REMARKS

Reconsideration and further examination of the subject patent application in light of the present Amendment and Remarks is respectfully requested.

Fig. 14b

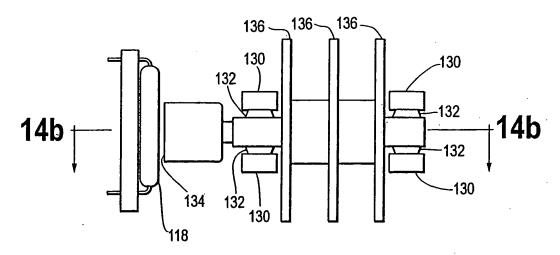
Reference number 138 has also been added to Replacment Sheet FIG. 14b. An Annotated FIG. 14b is also included.
